Office Action Summary	Application No. 10/500,192	Applicant(s) HIROTA ET AL.	
	Examiner Erik Kashnikow	Art Unit 4174

DETAILED ACTION

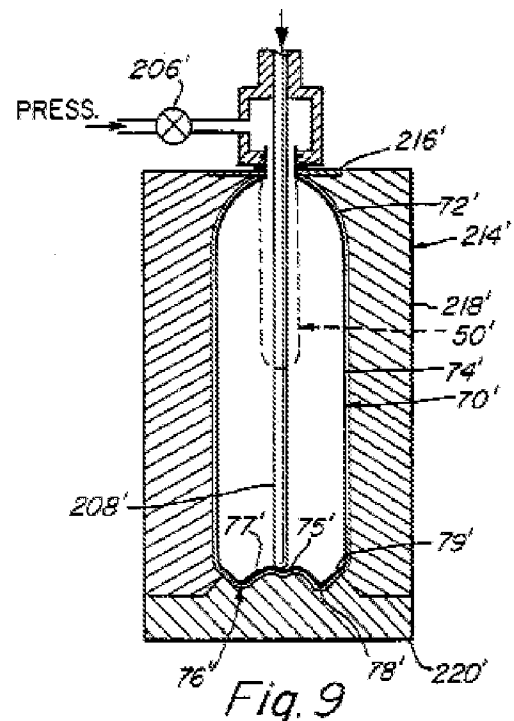
1. Figures 9 and 10 should be designated by a legend such as --Prior Art-- because only that which is old is illustrated. See MPEP § 608.02(g). Corrected drawings in compliance with 37 CFR 1.121(d) are required in reply to the Office action to avoid abandonment of the application. The replacement sheet(s) should be labeled "Replacement Sheet" in the page header (as per 37 CFR 1.84(c)) so as not to obstruct any portion of the drawing figures. If the changes are not accepted by the examiner, the applicant will be notified and informed of any required corrective action in the next Office action. The objection to the drawings will not be held in abeyance.

Fig. 11

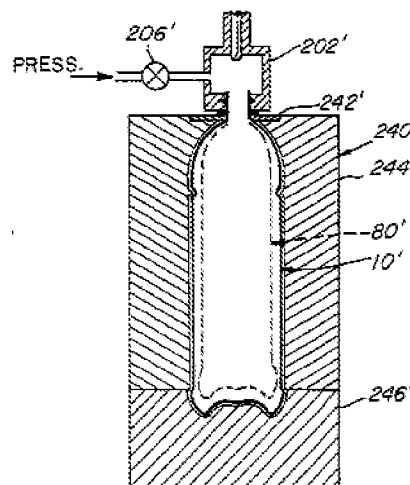
stretched by a stretching rod (figure 9 and column 9 lines 53-58). Collete et al. then teach the stretch rod be released by an internal spring, therefore making the bottom unrestrained before heat shrinking the intermediate product (figure 11 and column 10 lines 29-54). Collette et al. then perform a second step of blow molding to obtain the final project (column 10 lines 54-56).
